59-F-11
W.P. # 159-58
Hwy. # 401
REV. CROSSING
Hwy. # 2
1 MILE W. OF
TILBURY

DEPARTMENT OF HIGHWAYS - ONTARIO			
MATERIALS & RESEARCH SECTION			
HWY 2 PROP. REV'N. PROPOSED CROSSING			
SHOWING POSITIONS & ELEVATIONS OF HOLES			
HWY 401	DISTRICT 1	COUNTY ESSEX	
TOWNSHIP TILBURY NORTH	LOT 19	CON IV	
LOCATION	MATERIALS & RESEARCH SECTION		
DRAWN BY: T. MELLOR	CHECKED BY:	W.P. 159-58	
DATE: APR. 3, 1955	APPROVED BY:	DRAWING NO.	
SCALE: 1" = 20'		F59-11A

Re: Foundation Report -
W.J. F-59-11 -- W.P. 159-58,
Hwy. 401 Line 'B' & Hwy. 2 Revision
Crossing, Lot 19, Con. IV, Twp. of
Tilbury North.

4. Drawing F-59-11A -

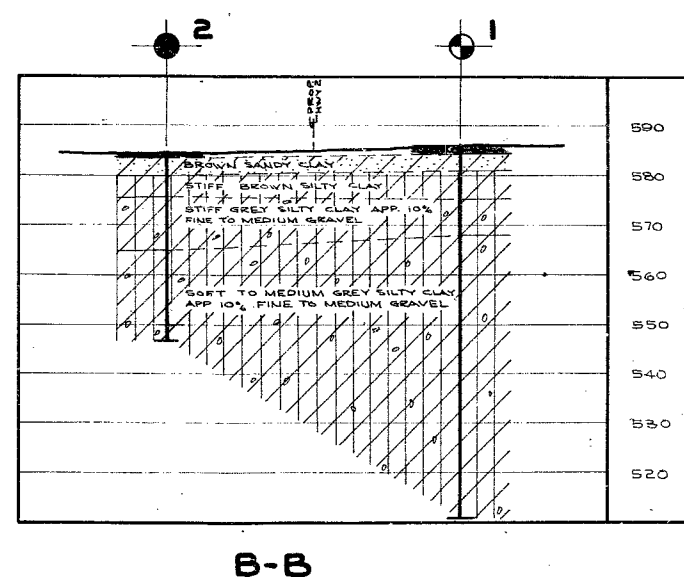
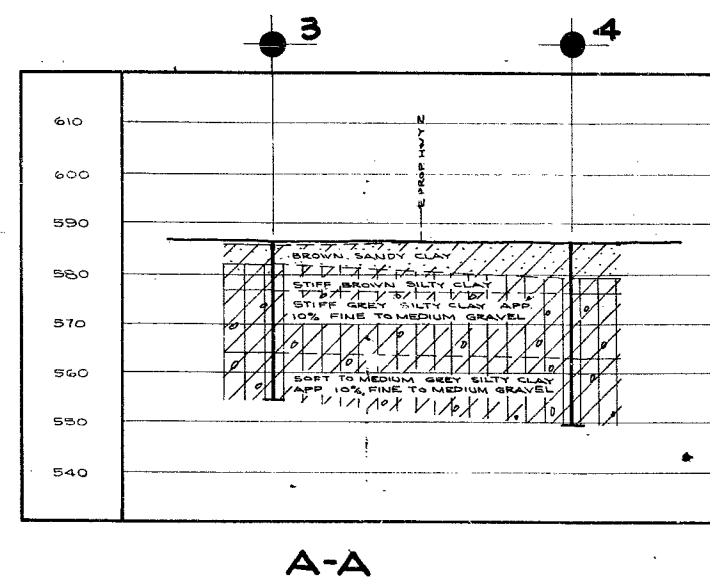
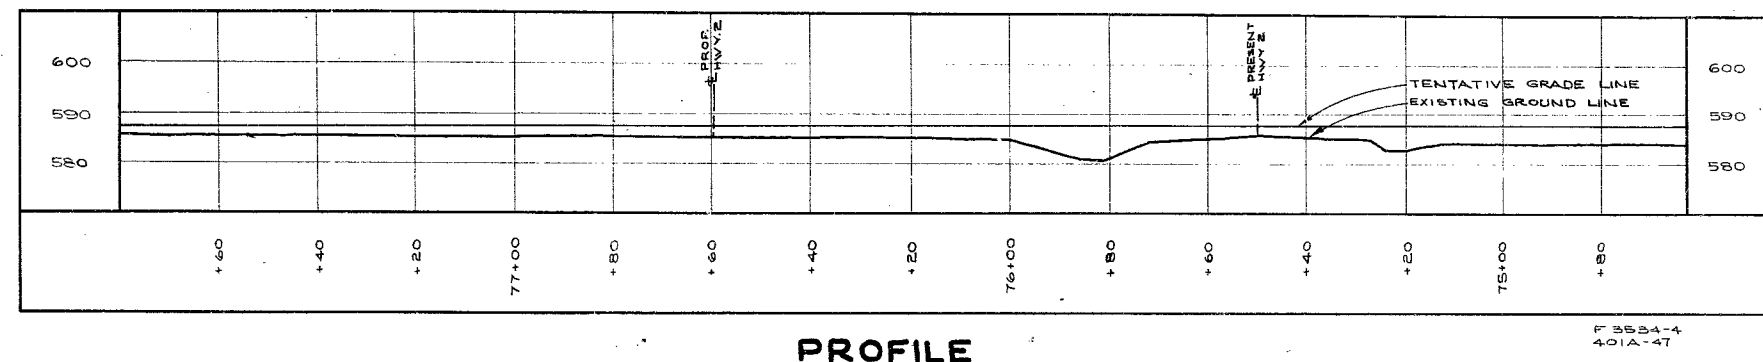
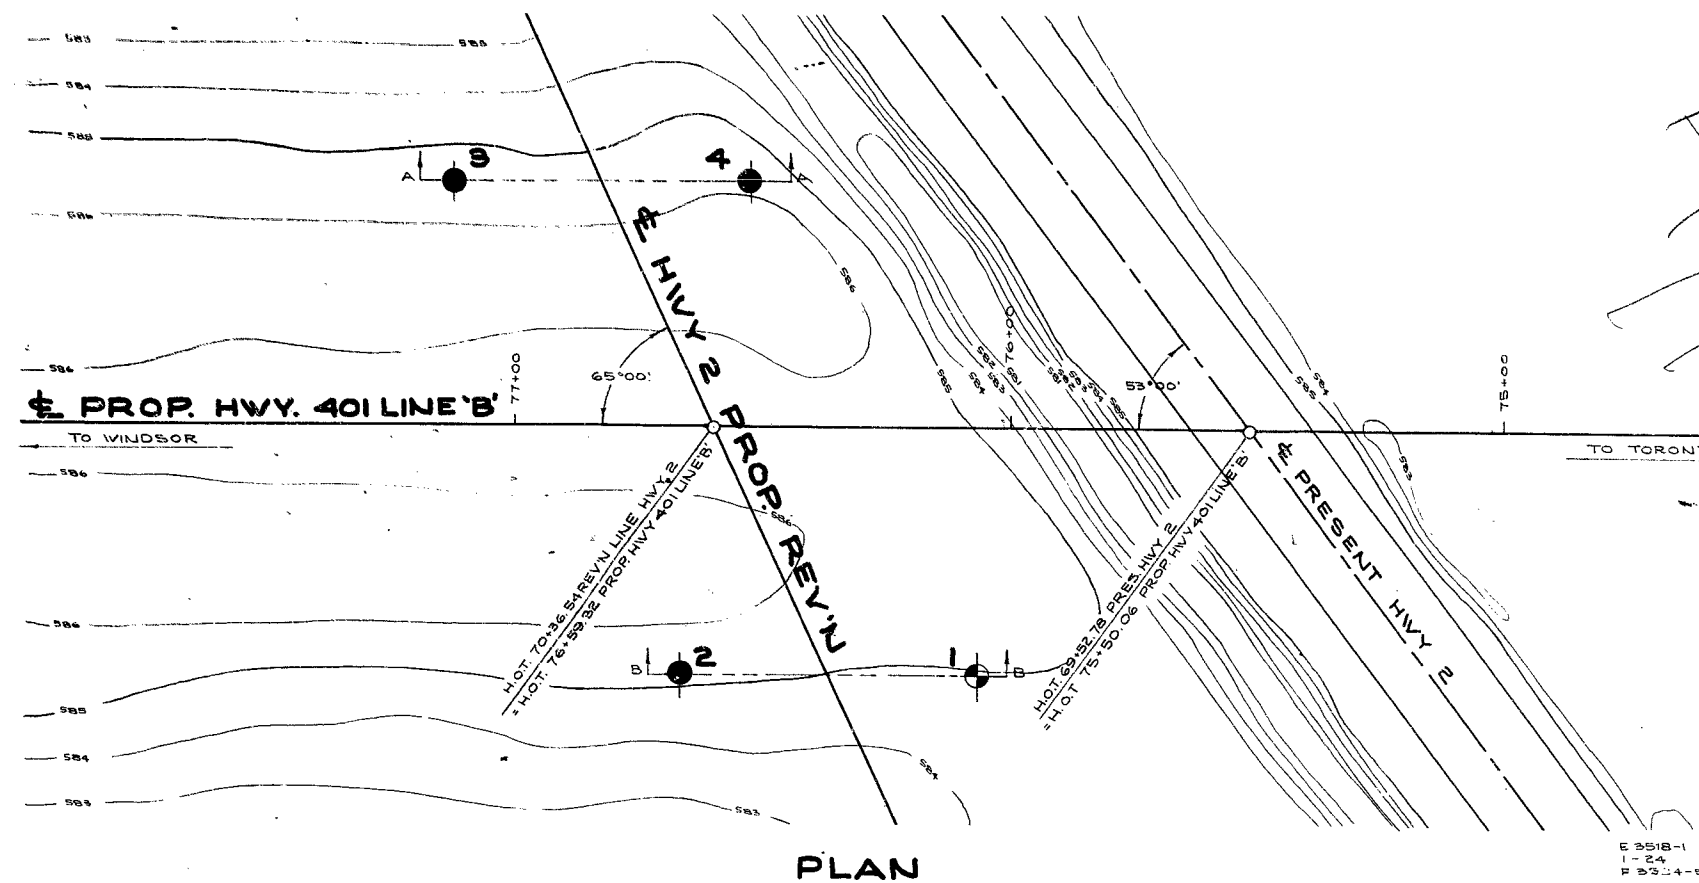
A. Key plan should be discarded.

B. Location: 1 1/4 Miles N.E. of Tilbury -
should be changed to:

1 Mile West of Tilbury.
